Product Change Notice:

1001-011-01101: Molding/tooling modifications:

For USB connector 1001-011-01101 – with date codes AFTER 20/01:

Adjusted/new PCB

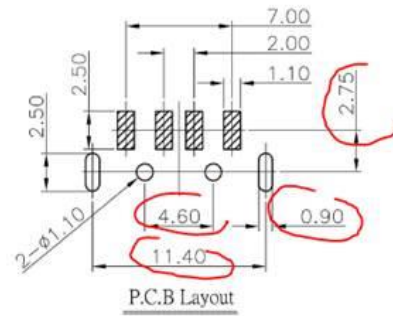
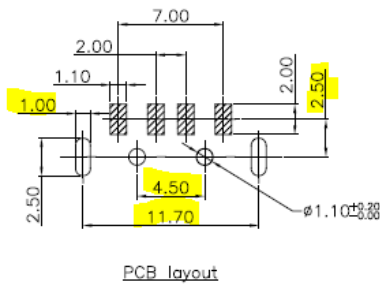
Tooling for 1001-011-01101 (CONNECTOR USB, 1.1, 4P, A/M, ULTRA FLAT, 1μ", SMT, R/A, HORIZONTAL) had to be adjusted, which created slight changes on the PCB layout.

.X = +/- 0.20mm

.XX = +/- 0.15mm

.X = +/- 0.38mm

.XX = +/- 0.25mm
